# Clearfield City Council Work Session

LOTUS ANTHEM  
Development Agreement  
1<sup>st</sup> Addendum

# Clearfield City Council Policy Session

TOWNS AT UNIVERSITY PARK  
Final Subdivision Plat  
FSP 2022-090046

# Phase 1

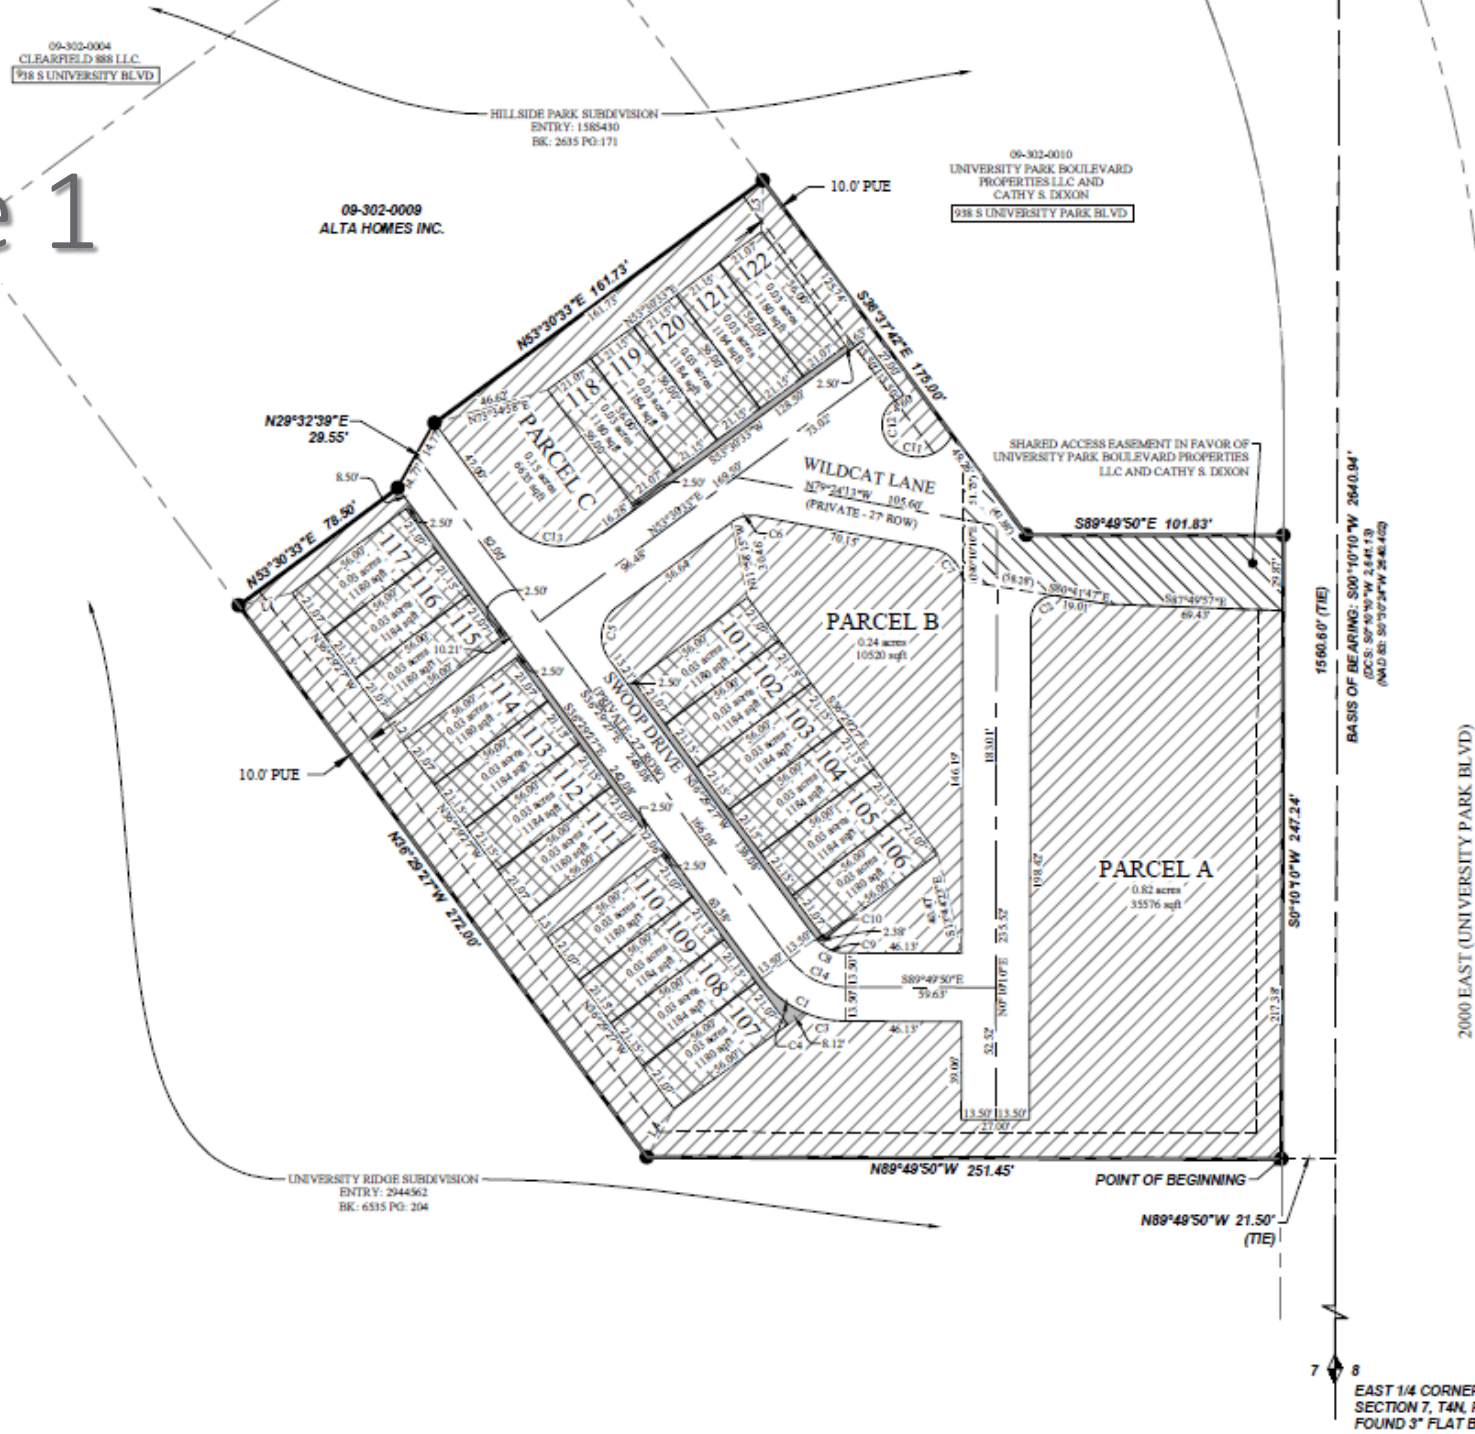
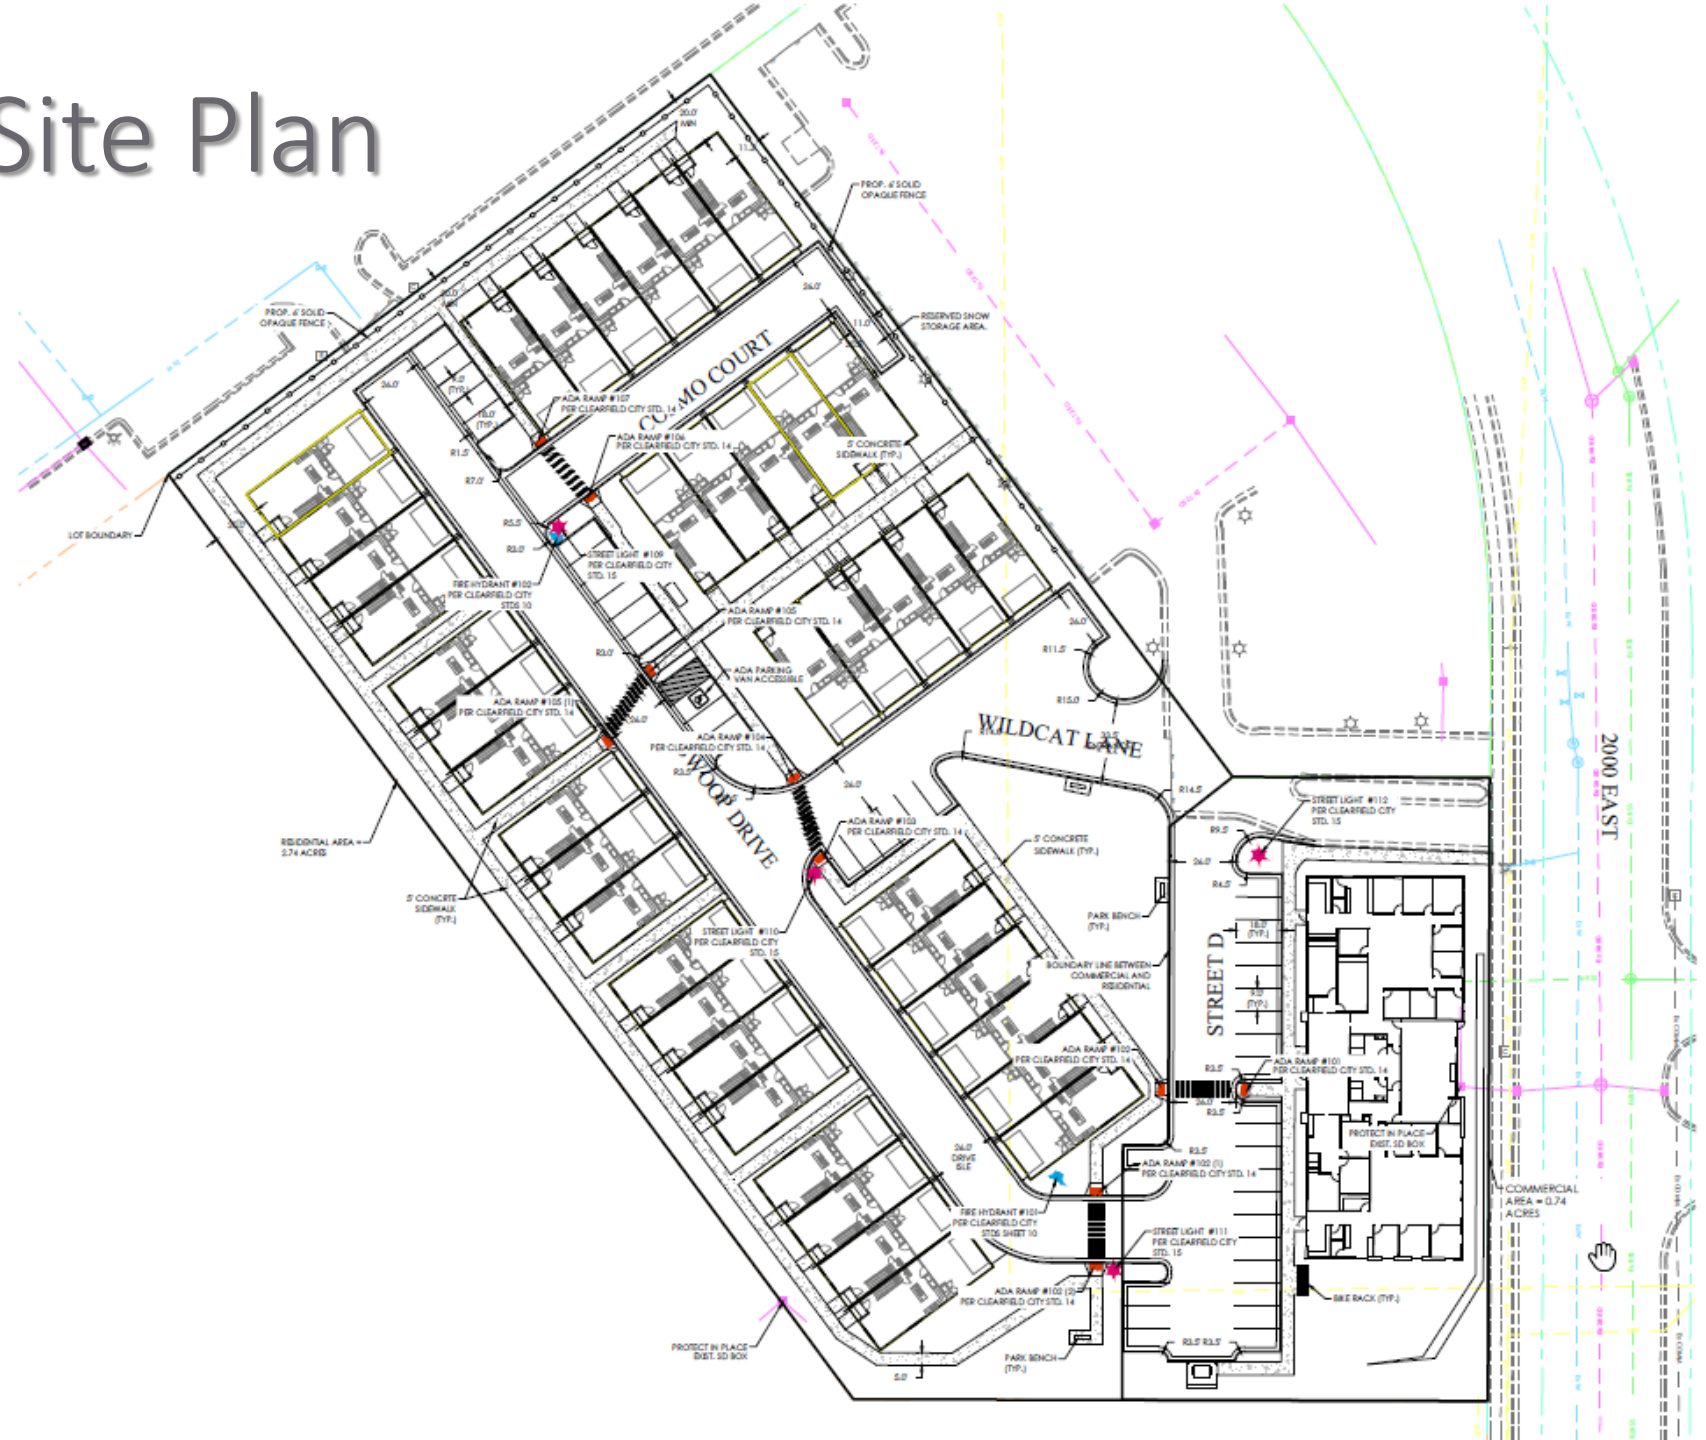
- 1) The plat shall be revised to include addresses for the townhomes.
- 2) The subdivision plat and improvement drawings shall be revised to address Clearfield City Planning and Engineering requirements prior to final approval.

- 5) A shared access easement between the subject property, the existing office building to the north, and the future commercial property will need to be recorded on the plat.
